## PLANNING REPORT

**RE:** Mattison Estates  
701 S. Bethlehem Pike  
Upper Dublin Township  
Montgomery County, PA

**DATE:** 9 December 2016

**SITE PLAN**

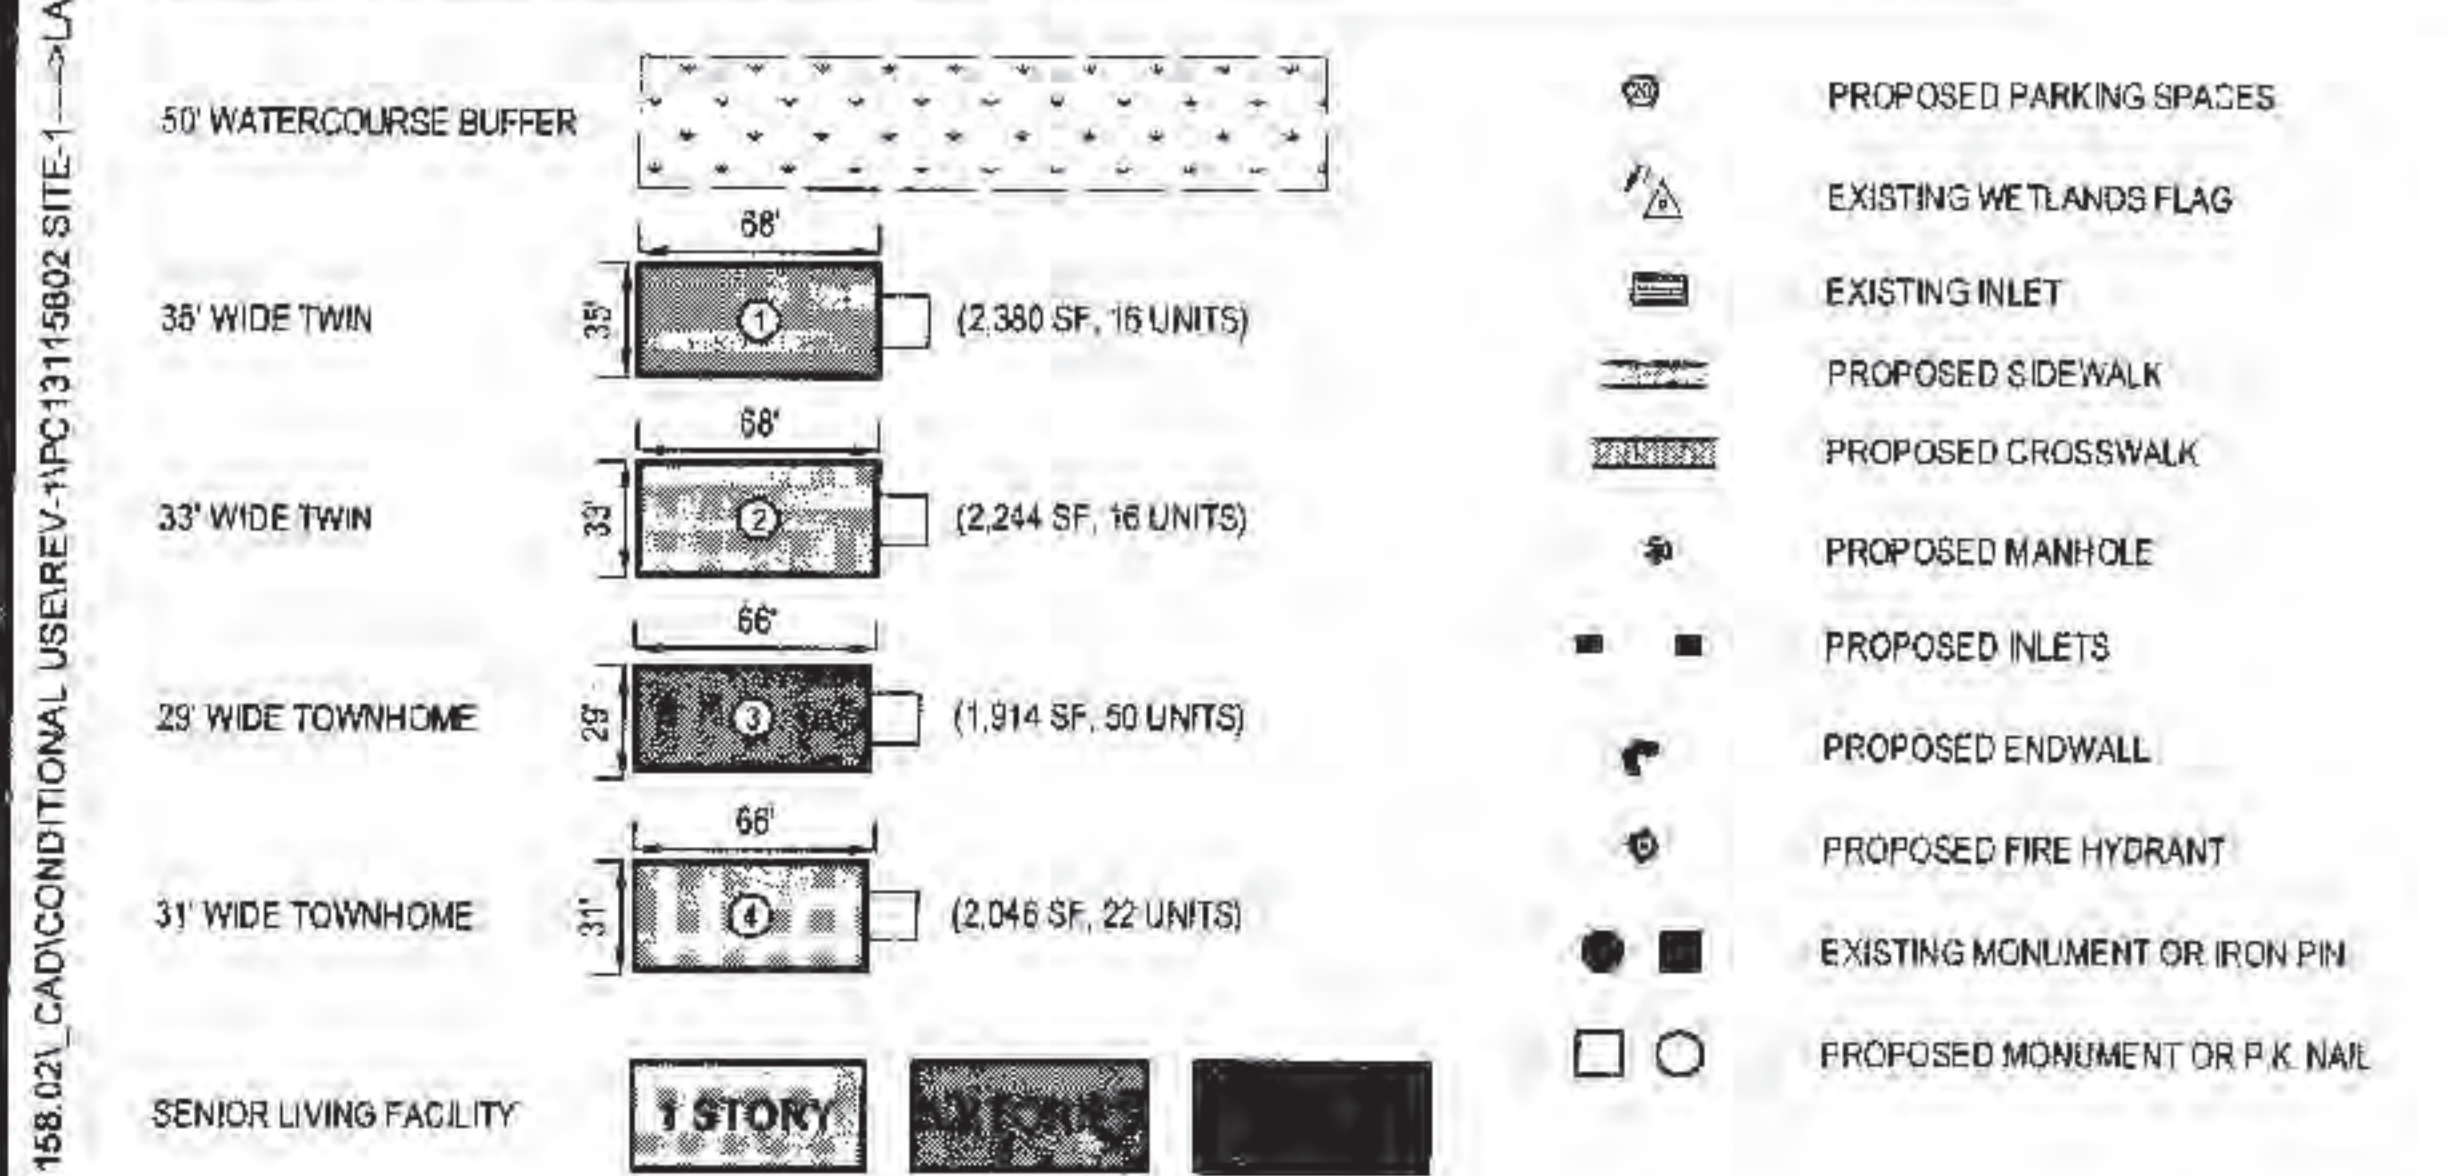
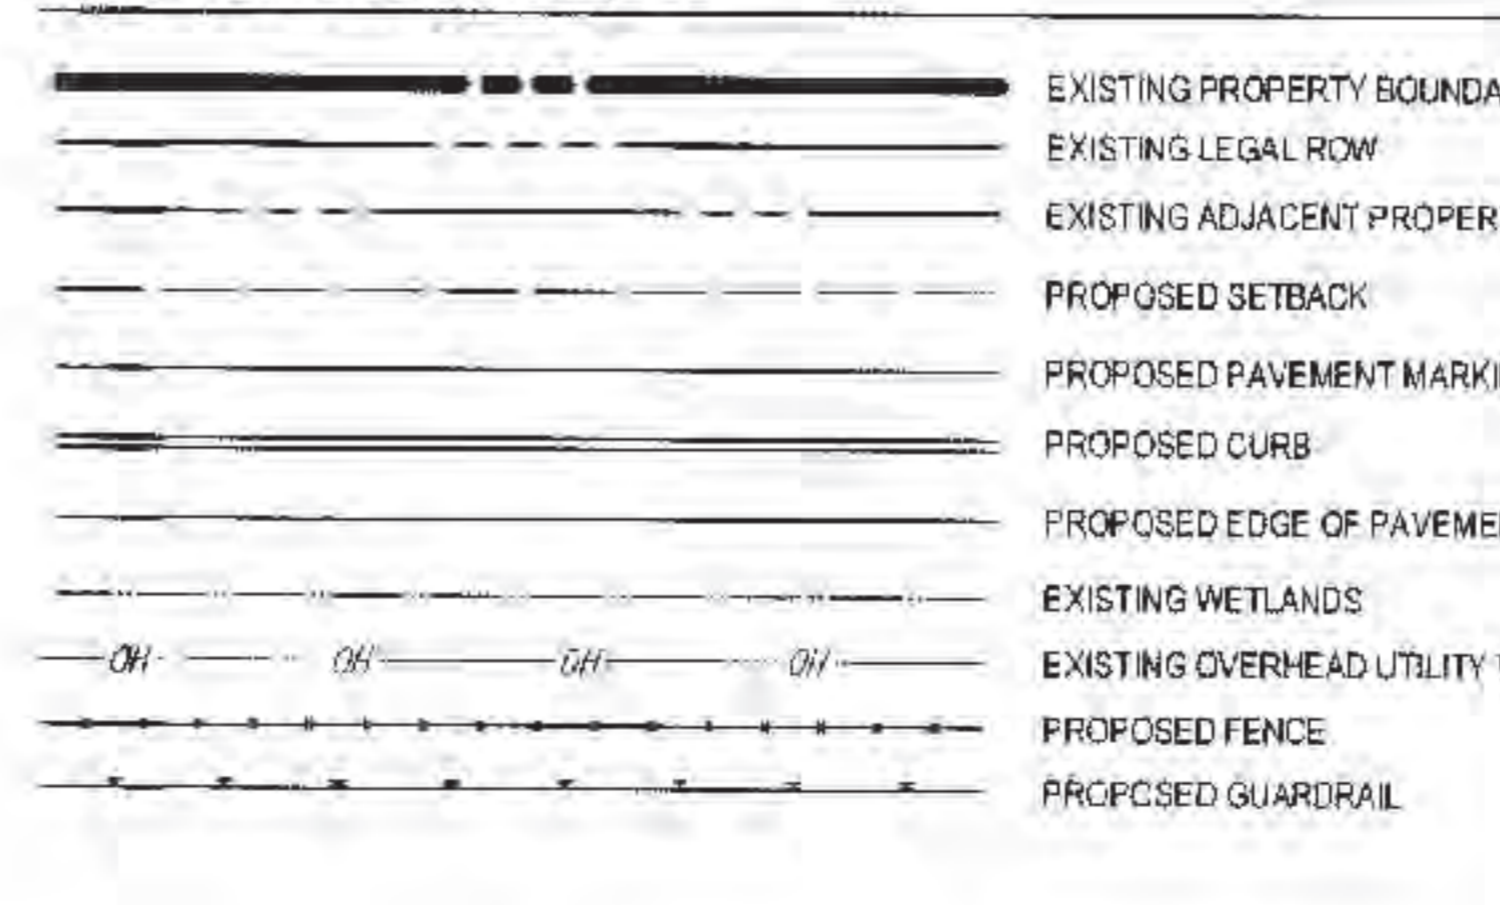
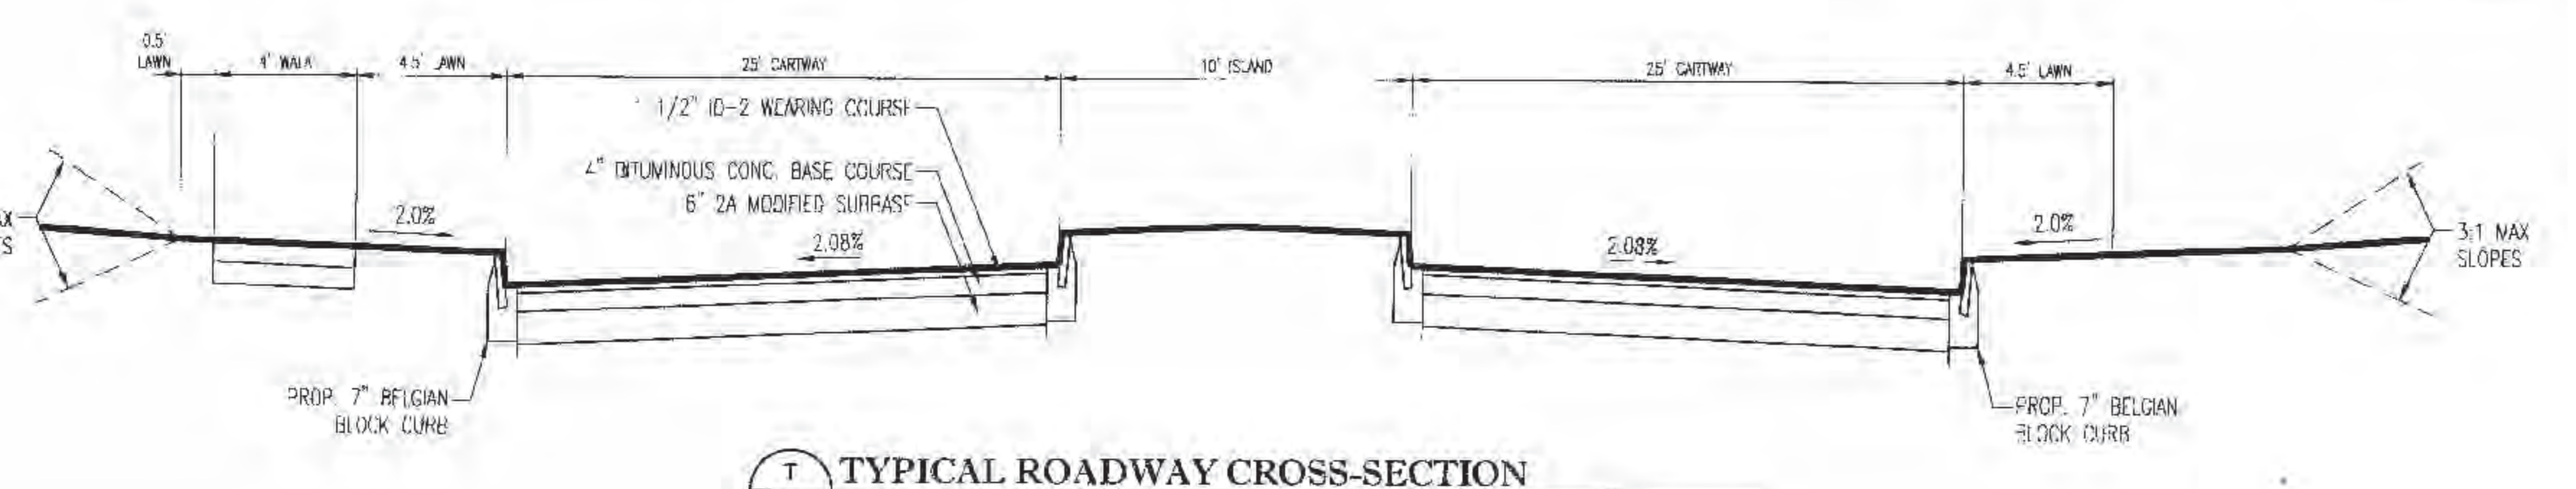
Twin (carriage) homes and townhomes are required to be set back a minimum of 20 feet from the curb when not along the main entry drive. The three-unit building located in the southwest area of the site that is adjacent to a trail connection measures less than 20 feet from the curb, and should be corrected. Careful consideration must be made when adjusting the plan to meet this requirement as other setback requirements must also be adhered to that are currently shown as meeting the minimum requirements on the plan. The minimum setback required along the main entry drive, adjacent to the median, is 30 feet. In addition, twin (carriage) homes and townhomes must have a minimum building separation of 20 feet. Finally, twin (carriage) homes and townhomes are required to have a minimum setback from the entry drive of 100 feet. With the exception of the three-unit building noted above, all setback requirements are being met on the current plan.

Insufficient 20' Setback

1. Ensure that all setback requirements are met, specifically the required 20-foot minimum setback from the curb for all townhouses and carriage houses.
